## **LEGAL NOTICE EXETER PLANNING BOARD AGENDA**

**Re:** Willey Creek Company      PB Case #22-3 – Amended Site Plan

Re: Final Submission for  
Building D of the Active Adult Community off Ray Farmstead Road  
Assessors Map 47 Lot 8  
Case #22-3  
UEI Comment Response

RAY FARM "BUILDING D"  
SITE DEVELOPMENT PLANS  
FOR AN ACTIVE ADULT COMMUNITY  
OFF RAY FARMSTEAD ROAD  
EXETER, NH

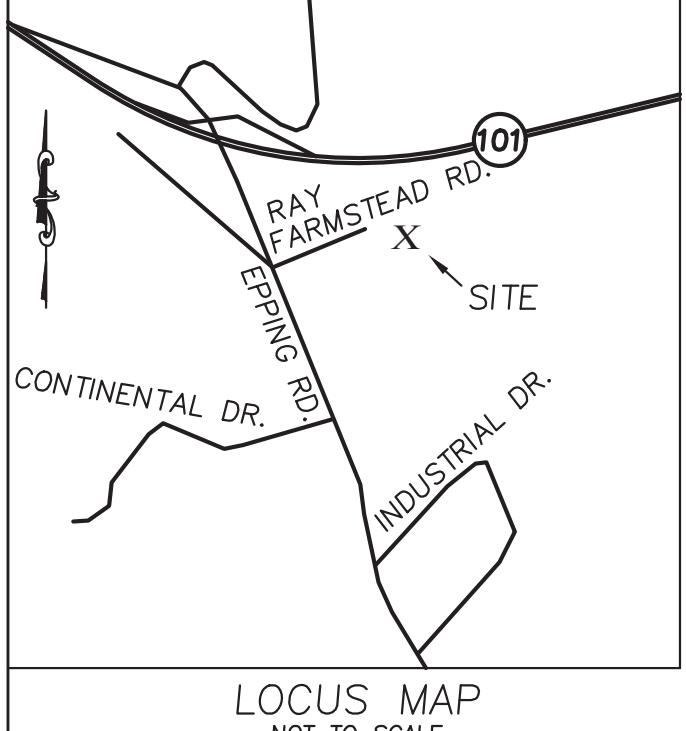
- The proposed driveway has been shortened, terminating in a stub rather than a loop, and the number of outdoor parking spaces has been reduced to 13. This results in less impervious surface on the site, promoting improved stormwater management. While fire trucks can no longer loop around, Sheets 16 and 17 demonstrate that they can safely enter, navigate, and exit the site. The revised layout has been shared with the Exeter Fire Department, who expressed support for the change.

- Parking is now proposed immediately adjacent to the building, eliminating the driveway between the spaces and the building.
- Retaining walls on the eastern corner of the site are no longer required due to the reduced grading achieved by mirroring the building. Previously, this area required a substantial excavation approximately 24 feet deep, but the revised design reduces this to roughly 15 feet. By minimizing the depth of the cut, we are able to replace the large retaining walls with a 1:1 riprap slope, which provides a stable, low-maintenance solution while reducing the visual severity of the vertical drop. This approach improves site safety and constructability and results in a more natural transition from top to bottom compared with two very tall retaining walls.

- The previous design also included a low point at the garage entrance on the north side of the building, where stormwater had no safe drainage path. This posed a risk of water accumulation, freezing, and potential flooding at the garage entrance. The revised design relocates the garage entrance and regrades the area, improving drainage, reducing freezing hazards, and enhancing overall site functionality.

**PLAN TITLE**  
**OVERALL SITE PLAN**  
SHEET: 7

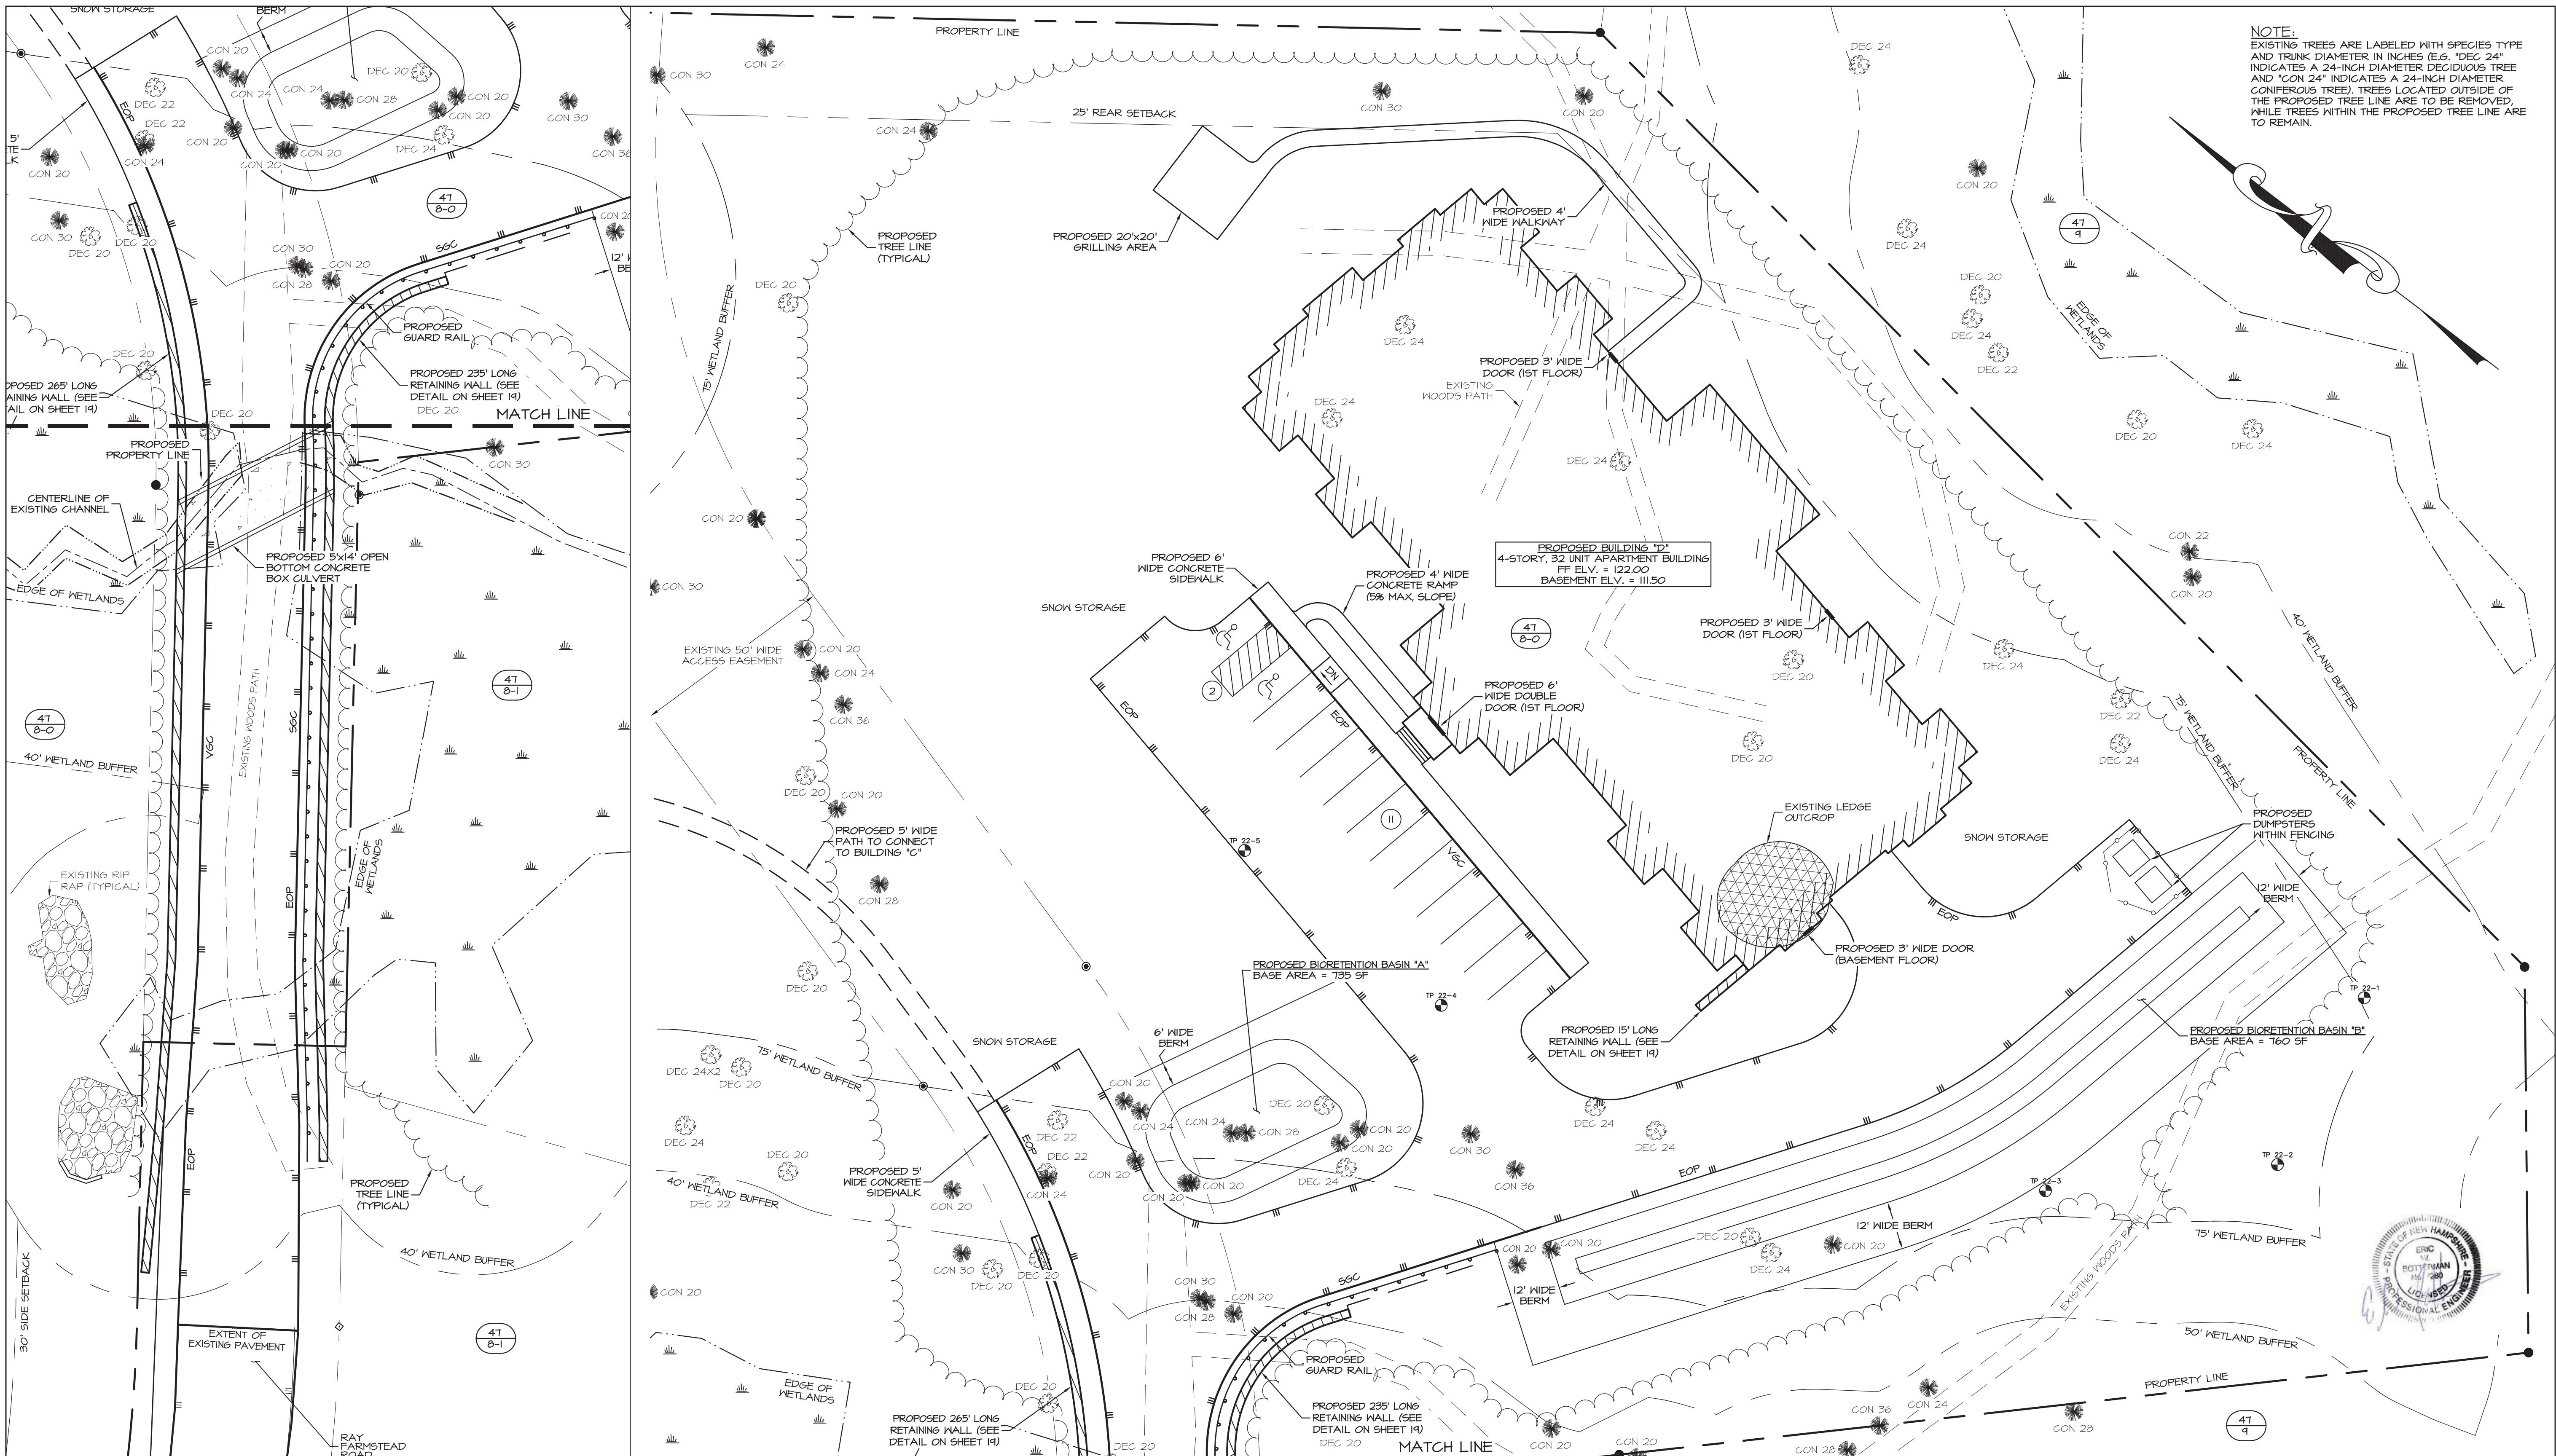
The applicant is requesting a waiver from the Site Plan Review Regulations that address the distance between buildings and driveways; the formal written request is included in the Board's packet.

On behalf of the applicant, Willey Creek Co., LLC, we respectfully request a waiver from the Town of Exeter Site Plan Review and Subdivision Regulations, as amended August 2023, specifically Section 11.3.1.2.a. This request is submitted as part of the Site Plan Application for the proposed construction of Building “D,” located off Ray Farmstead Road in Exeter, NH 03833. The applicable regulation is provided below in bold, followed by our justification for the waiver in italics.

*The Fire Chief has reviewed the pavement layout, emergency access, and hydrant locations, including the area of reduced setback, and has verbally confirmed that emergency response capabilities are fully maintained. Landscaping is also proposed between the parking lot and the building to provide screening for residents. Because the building is located within the wooded interior of the site and is not visible from public ways or abutting properties, the reduced setback has no impact on neighborhood character or public view corridors.*

*Maintaining the full 25-foot setback at the vestibule would result in site-grading constraints that would require driveway slopes exceeding 5 percent or would shift the ADA parking spaces away from the accessible entrance. Ensuring compliant grades and direct ADA access is particularly important for a 55+ community and aligns with the broader purpose of the Site Plan Regulations to provide safe, functional, and accessible site design. Allowing the 15-foot setback at this limited location therefore upholds the spirit and intent of Section 11.3.1.2.a.*
